**ADDENDUM NO. 2**

**FAIRFIELD AND INDIAN VILLAGE ELEMENTARY SCHOOL SITE IMPROVEMENTS**

**Fort Wayne Community Schools (FWCS)**

**February 9, 2026**

**3. Plan Sheet C601 – Landscape Plan**

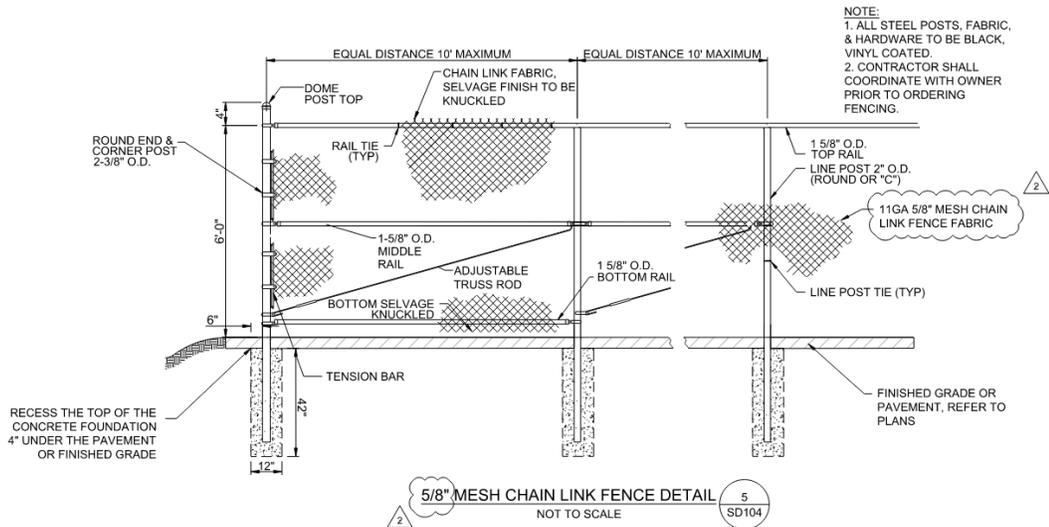
**REVISED:** Note 5 to remove the reference to irrigation

2. Sheet F603 note 5 mentions "Irrigation System shall be designed." Is this project to be irrigated to all disturbed areas and plant material?  
*Response: Note 5 on F603 and C601 has been revised to remove reference to irrigation, as it is not intended to have irrigation installed as a part of this project.*

5. PLANTING BEDS SHALL HAVE FINISHED GRADES SMOOTHED TO ELIMINATE PONDING OR STANDING WATER. CONTRACTOR SHALL MAINTAIN A MINIMUM 2% DRAINAGE AWAY FROM BUILDINGS AND PAVING INTO DRAINAGE STRUCTURE OR TO STREET. CONTRACTOR SHALL NOTIFY OWNER IMMEDIATELY OF ANY CONFLICTS IN MAINTAINING DRAINAGE.
